Access Compliance Report

Public Rights-of-Way

(Curb Ramps)

Intersection ID: 2969	Main Street: CREEK_BREEZE_RD	Cross Street: MEADOW_GREEN_DR	Location: SW
ADA ID: EF4D5FCBFC43	Ramp Type: PerpDiag	Initial Pass/Fail: Fail	Overall Compliance: No
			Severity Score: 21.25

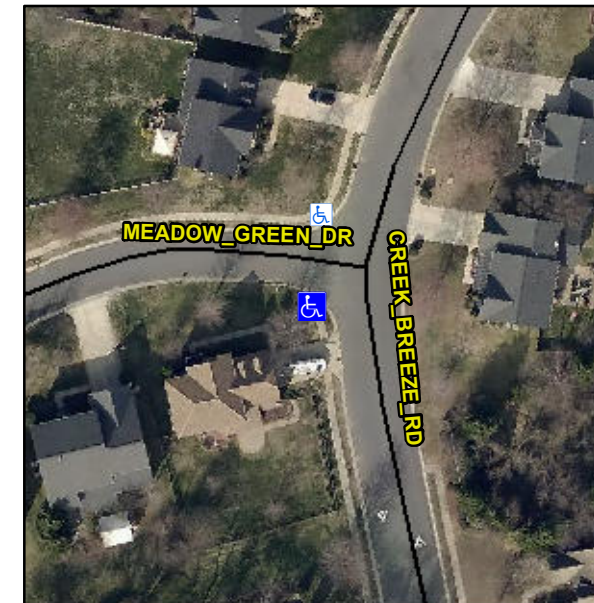
Not Found, R304.5.1, R304.2.2

Compliance	Description	Data	Compliance	Description	Data
N/A	Ramp Length (in)	40.0	No	Ramp Slope (%)	11.9
No	Ramp Width (in)	44.0	Yes	Ramp XSlope (%)	0.3
N/A	Flare Type LT	N/A	N/A	Flare Type RT	N/A
N/A	Flare Slope LT (%)	N/A	N/A	Flare Slope RT (%)	N/A
N/A	Flare Traversable LT?	N/A	N/A	Flare Traversable RT?	N/A
N/A	Landing Length (in)	N/A	N/A	DWS Provided?	N/A
N/A	Landing Width (in)	N/A	N/A	DWS Contrast?	N/A
N/A	Landing Slope (%)	N/A	N/A	DWS Length (in)	N/A
N/A	Landing X Slope (%)	N/A	N/A	DWS Full Width?	N/A
N/A	Landing Curb? (Y/N)	N/A	N/A	DWS Offset (in)	N/A
N/A	Shared Landing?	N/A			
N/A	Gutter Ponding?	N/A	N/A	Gutter Slope (%)	N/A
N/A	Gutter Lip Ht (in)	N/A	N/A	Gutter X Slope (%)	N/A
N/A	Painted X Walk1?	No	N/A	Painted X Walk2?	No
	X Walk 1 Direction	To E		X Walk 2 Direction	To N
N/A	X Walk 1 Width (in)	N/A	N/A	X Walk 2 Width (in)	N/A
	X Walk 1 Slope (%)	0.6		X Walk 2 Slope (%)	1.3
	X Walk 1 X Slope (%)	0.3		X Walk 2 X Slope (%)	0.1

Remove & Replace Curb Ramp With Two New Directional Ramps or Equivalent.
